# Discussion of Simplified Plan EO

July 10, 2017

# Discussion of Simplified Plan EO

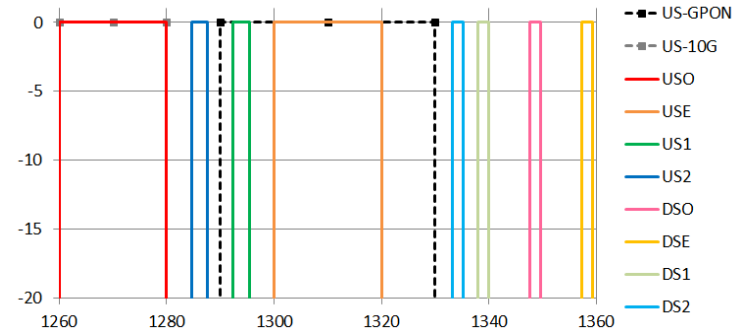
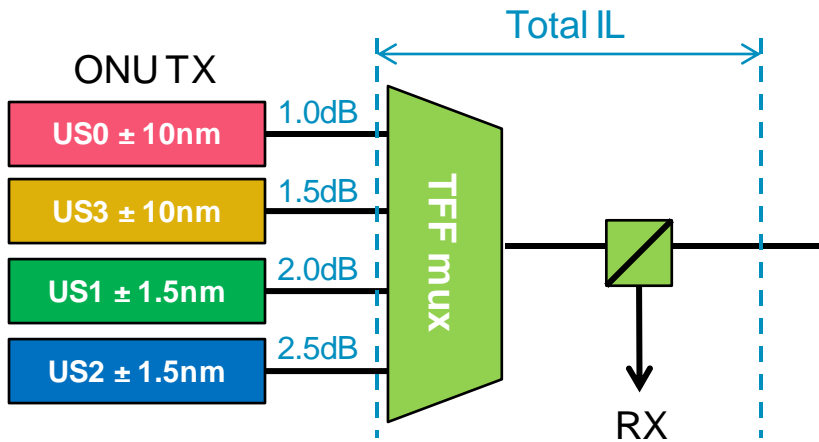
- There are minor issues with Simplified Plan EO that warrant discussion:
  - DS passband width is only 2nm. Should be  $\leq 3$ nm for lower cost.
  - Having more than one wide US channel adds complexity and penalties.

- 100G ONU Tx are unlikely to use uncooled lasers due to high mux/demux insertion losses.
    - 20nm wide channels have increased SOA noise penalty in pre-amplified 100G OLT RX.

- The solution is to define both cooled and uncooled channels at 1270 and 1310nm.
  - Having two different downstream 25G wavelengths could enable proprietary implementation of two independent 25G PONs on the same ODN, but...

- Multiple 25G pairs on the same PON is not in scope. See [Motion #3, March 2016 meeting](#).
    - Increased operational complexity of deploying two different versions of 25/25G ONUs.

- Increased manufacturing cost of supporting two different versions of 25G OLT optics.
    - A single downstream wavelength plan is preferred for both coexistence options.

# 100G ONU TX with two wide channels

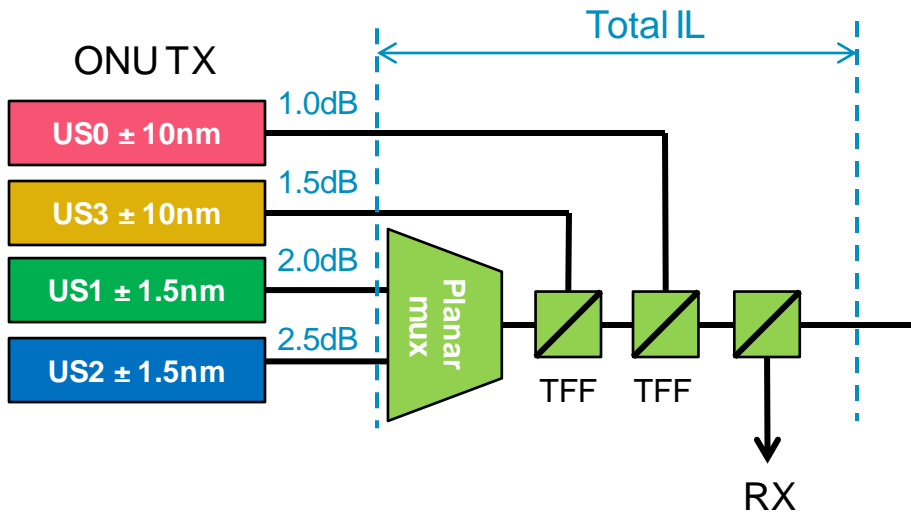
- TFF mux enables lowest IL on US0, but US1 has increased loss – difficult to implement with uncooled laser.
- Planar mux can handle non-uniform channel spacing, but can't do non-uniform passband width easily – must demux wide channels separately with TFF.
- Implementation with planar mux of 50G channels is complicated.
- OLT demux configurations are similar to ONU mux.

# Solution: Define narrow US0/3 for 100G

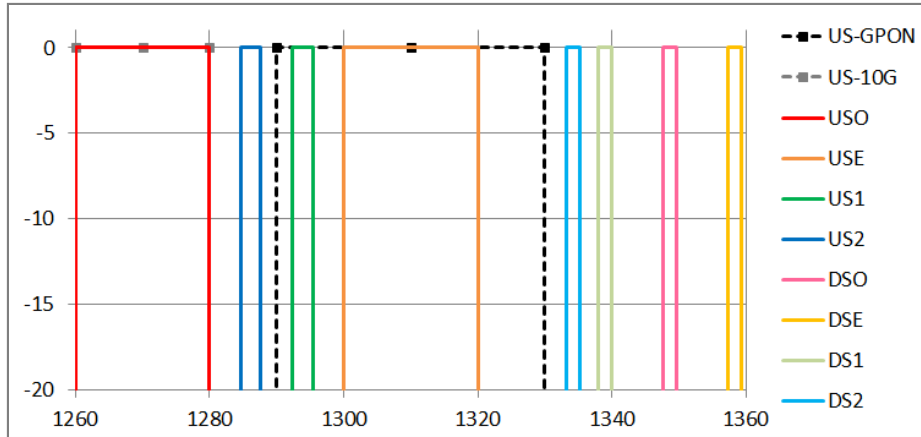
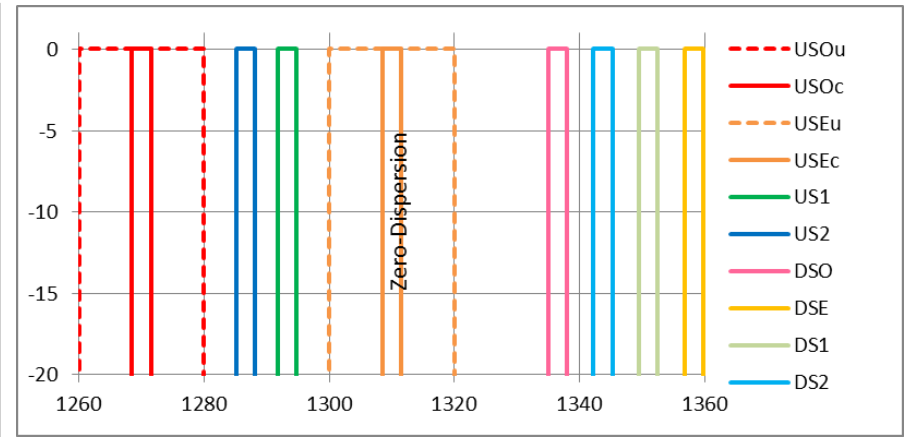
- For 100G ONU TX, cooled lasers will be used to overcome mux and demux losses totaling  $\sim 5\text{dB}$ .
- Define cooled laser wavelengths at center of uncooled channel for use by 100G TX.
- Cooled channel passband width = 3nm
- Uncooled 25G and cooled 100G TX use the same laser chip – no yield loss for cooled version, reducing cost of 100G TX.
- 100G OLT RX must still have first channel passband 20nm wide for 25G ONUs.
